Access Compliance Report

Public Rights-of-Way

| Intersection ID: 26714 | Main Street: NANCY_CREEK_RD | Cross Street: OPEN_BOOK_LN | Location: SE |
| ADA ID: 7DE797447C9D | Ramp Type: BlendTrans1 | Initial Pass/Fail: Fail | Overall Compliance: No |

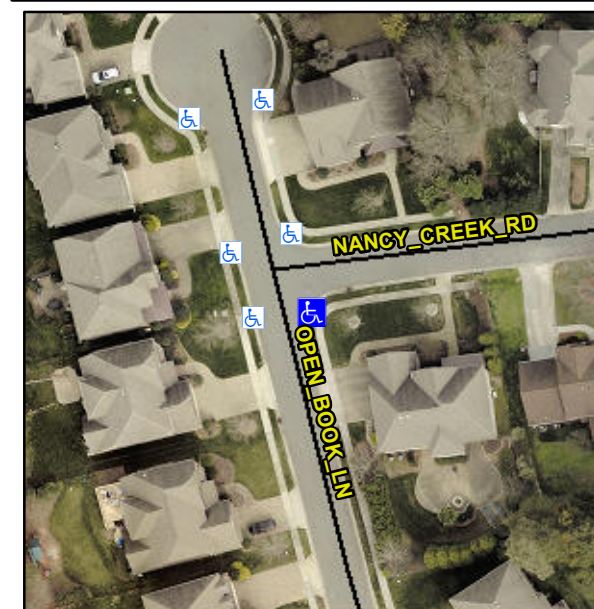
Not Found, R304.5.3

| Compliance | Description | Data | Compliance | Description | Data |
|------------|-----------------------|------|------------|-----------------------------|------|
| Yes | Ramp Width (in) | 48.0 | No | BlendTrans XSlope (%) | 5.2 |
| | | | No | Curb Slope (%) | 17.0 |

Remove & Replace Curb Ramp With Two New Directional Ramps or Equivalent.
